Access Compliance Report

Public Rights-of-Way

Intersection ID: 13780	Main Street: ELIZABETH_AV	Cross Street: N_TORRENCE_ST	Location:	N
ADA ID: DB1BEB2E90DF	Ramp Type: Perp	Initial Pass/Fail: Fail	Overall Compliance: No	Severity Score: 10

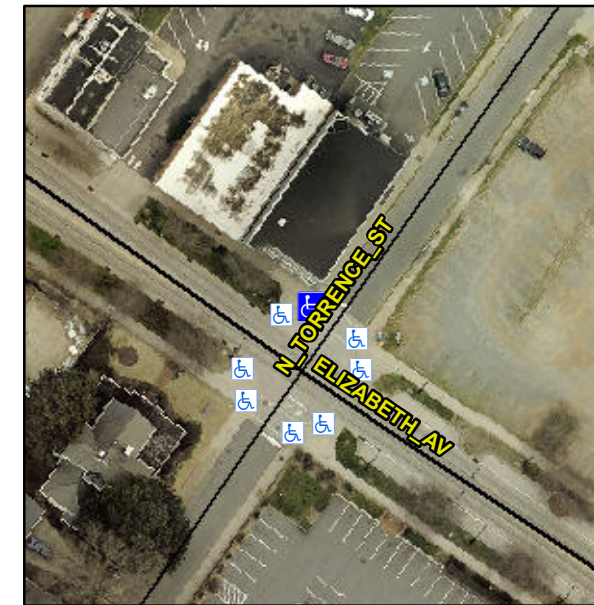
Not Found, R304.5.1, R304.5.3

Compliance	Description	Data	Compliance	Description	Data
N/A	Ramp Length (in)	77.0	Yes	Ramp Slope (%)	6.6
No	Ramp Width (in)	47.5	No	Ramp XSlope (%)	3.3
N/A	Flare Type LT	N/A	N/A	Flare Type RT	N/A
N/A	Flare Slope LT (%)	N/A	N/A	Flare Slope RT (%)	N/A
N/A	Flare Traversable LT?	N/A	N/A	Flare Traversable RT?	N/A
N/A	Landing Length (in)	N/A	N/A	DWS Provided?	N/A
N/A	Landing Width (in)	N/A	N/A	DWS Contrast?	N/A
N/A	Landing Slope (%)	N/A	N/A	DWS Length (in)	N/A
N/A	Landing X Slope (%)	N/A	N/A	DWS Full Width?	N/A
N/A	Landing Curb? (Y/N)	N/A	N/A	DWS Offset (in)	N/A
N/A	Shared Landing?	N/A			
N/A	Gutter Ponding?	N/A	N/A	Gutter Slope (%)	N/A
N/A	Gutter Lip Ht (in)	N/A	N/A	Gutter X Slope (%)	N/A
N/A	Painted X Walk1?	Yes	N/A	Painted X Walk2?	N/A
	X Walk 1 Direction	To SE		X Walk 2 Direction	N/A
N/A	X Walk 1 Width (in)	110.0	N/A	X Walk 2 Width (in)	N/A
	X Walk 1 Slope (%)	4.1		X Walk 2 Slope (%)	N/A
	X Walk 1 X Slope (%)	1.8		X Walk 2 X Slope (%)	N/A

Remove & Replace Entire Ramp.
